Release Note

Edgecore EAP101 Release v12.3.0

Document # EAP101-v12.3.0-862-4973a8d6

Enhancement from v12.2.0-780-fa0042e7

1.1 Interference Detection Enhancement

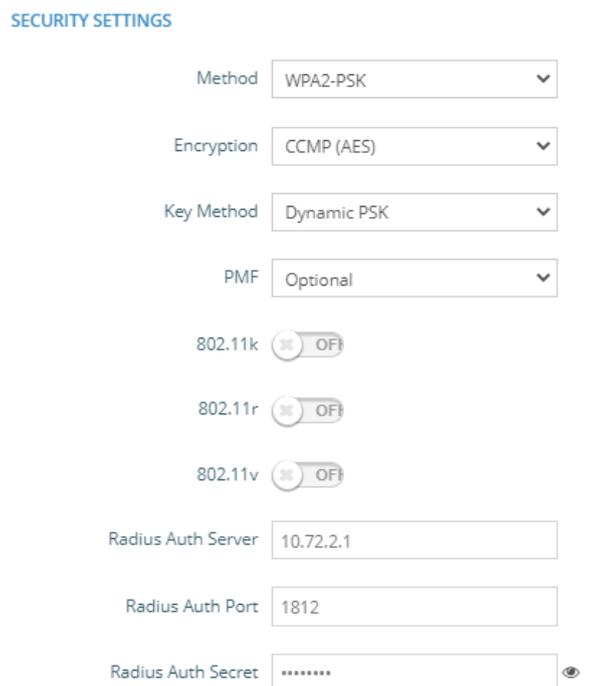
When utilization of the current or adjacent channel reaches the configured threshold (in %), enhance the channel selection mechanism to select the better channel with the lower utilization.

1.9 QR Code Onboarding Enhancement

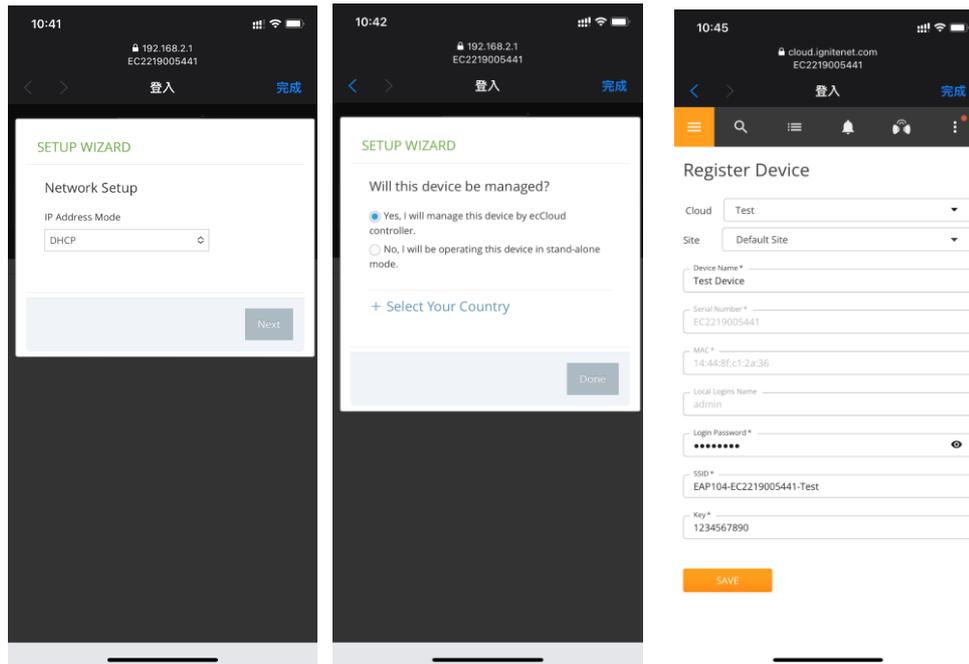
When the AP is reset to default, use the phone to scan the QR code under the device. The

browser will redirect to setup wizard page. In network setup page, DHCP, static IP, PPPoE can be configured depending on the network environment.

If selecting “stand-alone mode”, the SSID, user name and password can be configured in the setup wizard page.

If selecting “managed by Cloud”, the page will guide to ecCLOUD for registering the AP information including MAC and Serial Number. The SSID, user name and password can be configured in the register device page. QR code onboarding can help speed up the register process of the AP on ecCLOUD without typing the AP information.
